WORK ORDER NON-CONFORMANCE / UPDATE

Work Order ID 133962

DESIGN 90	DRAWN BY SC	DART AEROSPACE LTD HAWKESBURY, ONTARIO, CANADA	
CHECKED 90	APPROVED [Signature]	DRAWING NO. D3592	REV. B SHEET 1 OF 1
DATE 07.05.31	TITLE PLATE SCALE 1:1		
A	07.01.15	NEW ISSUE	
B	07.05.31	TOOLING HOLES ADDED

DRAWING NO. D3592	TITLE PLATE	REV. B	DART AEROSPACE LTD ENGINEERING ORDER		D.E.O. NO. D3592-B-1	SHEET NO. SHEET 1 OF 1	SCALE NTS
DRAWN AJS	CHECKED L	MFG. APPR. AA	APPROVED WPD		DE APPR. -H-		
DATE 08.09.11	DATE 08.09.11	DATE 08/09/11	DATE 08/09/11		DATE 08/09/11

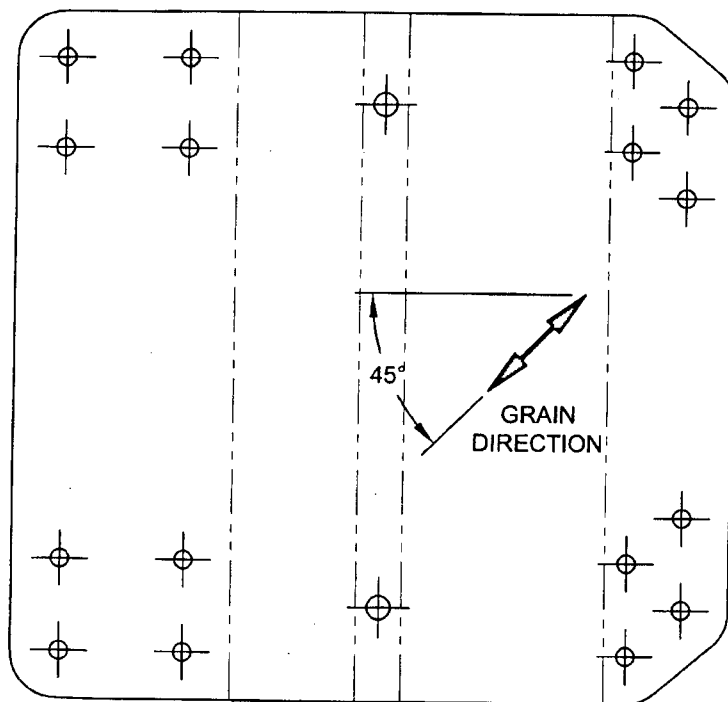
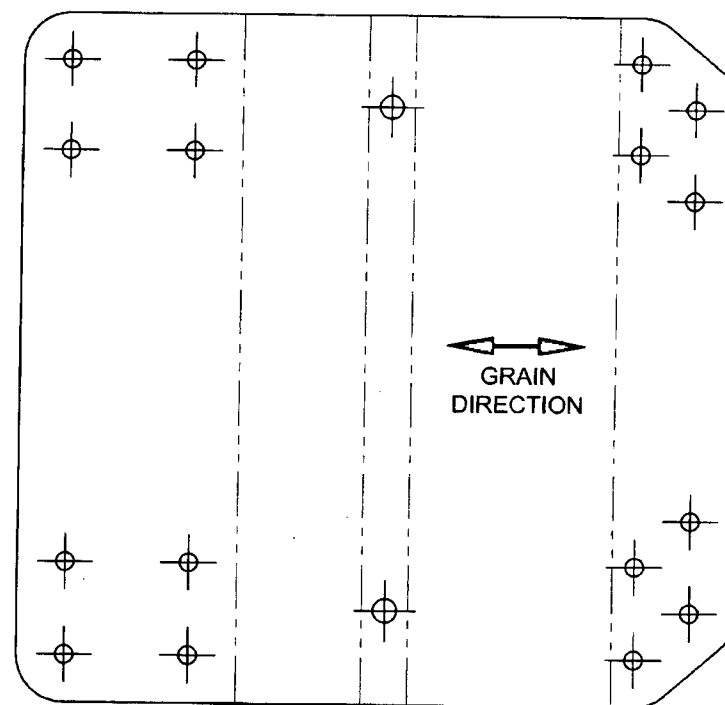
MODIFY GRAIN DIRECTION AS SHOWN BELOW TO PREVENT CRACKING WHEN WELDING AT ASSEMBLY (SEE CAR 08-026).

IS:

WAS:
